Appendix FEIR-A

Comment Letters on the Draft EIR

RE: 4th and Hewitt Project - Draft Environmental
Impact Report (DEIR)
SCH# 2017091054
GTS# 07-LA-2017-03964
Vic. LA-101 PM 0.633

**Re: Comment on Draft Environmental Impact Report, 4th and Hewitt Project
(ENV-2017-470-EIR, SCH 2017091054)**

FIGURE II-13

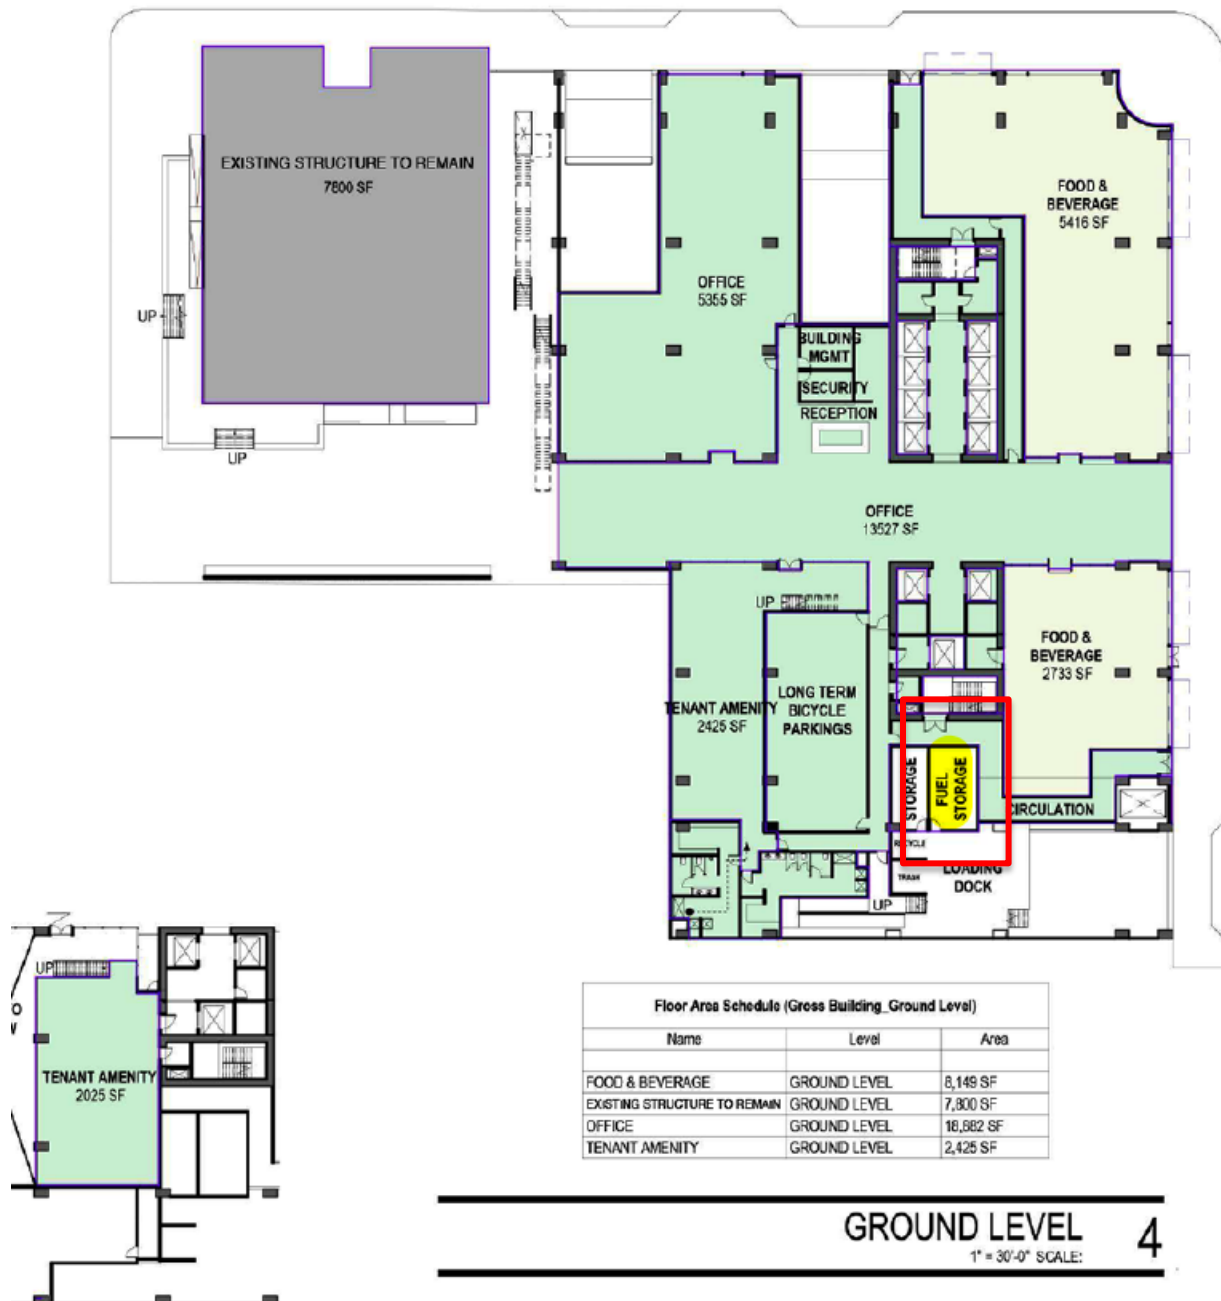
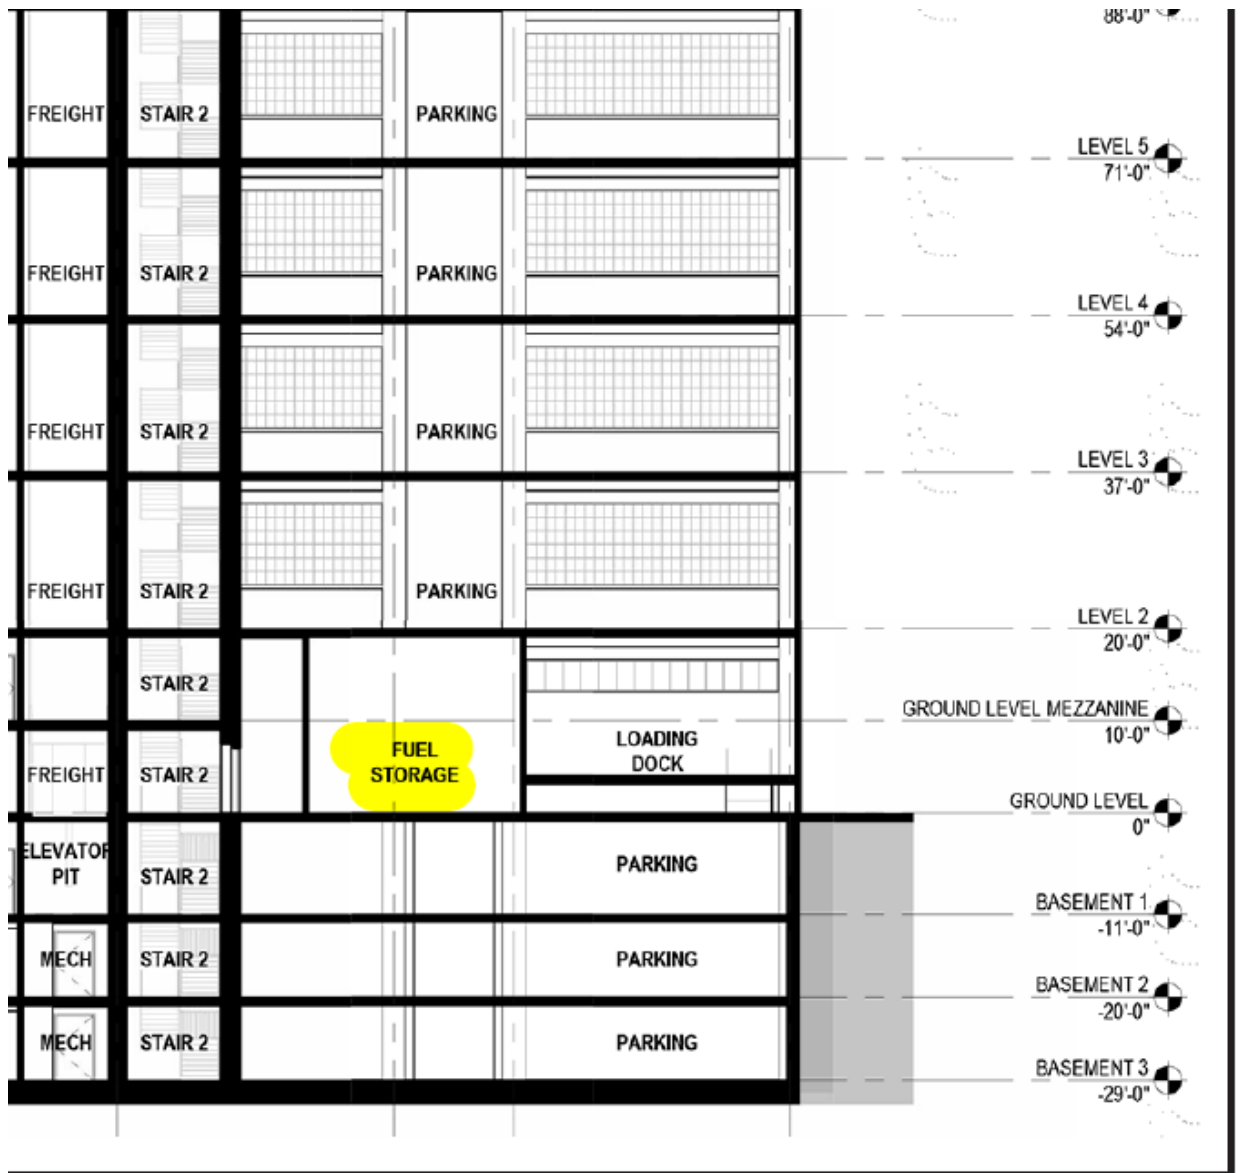
A review of the project plans provided in the DEIR clearly shows a room on ground level 4 as being designated as Fuel Storage adjacent to the loading dock. No explanation is given in the DEIR as to what will be stored, how much will be stored, and what the fuel will be used for. In addition to being a fire hazard, fuels stored on site contain hazardous materials that have not been disclosed in the DEIR.

The transverse cross section of the building in Figure II-13 shows that the Fuel Storage area would be involve a significant volume on ground level 4. The City's failure to disclose this fuel storage area, to analyze the potential emissions, quantify the health risk associated with the stored fuel are major flaws in the DEIR and may be placing the residents in the building and the adjacent structures at risk from the operational phase of the project.
